Terminal Units

January, 2005

FPTU w/SM Liners and Inlet Attenuators

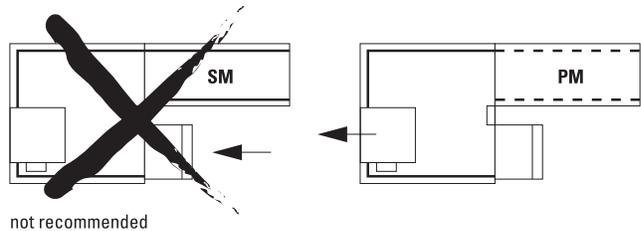
Occasionally, fan terminals are specified to have solid metal liners (SM) to eliminate the possibility of exposed fiberglass and to add rigidity to the units casing. However, it should be noted that the SM liner negates any sound absorption of the encased insulation, significantly increasing radiated noise levels.

Typically, an inlet attenuator is selected to reduce radiated noise. The addition of a SM lined inlet attenuator will not provide any noise reduction or acoustical benefit while adding to the overall weight, size, and cost of the terminal. As a result, when any Fan Powered terminal unit is ordered with SM liner and an inlet attenuator section, the inlet attenuator will be supplied with a perforated metal (PM) liner.

The inlet attenuator will be constructed with two inch fiberglass insulation covered with perforated metal that has a low free area (12%) which effectively contains and protects the fiberglass insulation. The small perforations of 3/32" dia staggered at 1/4" inch allow sound waves to pass through, providing acoustic absorption which reduces radiated sound levels.
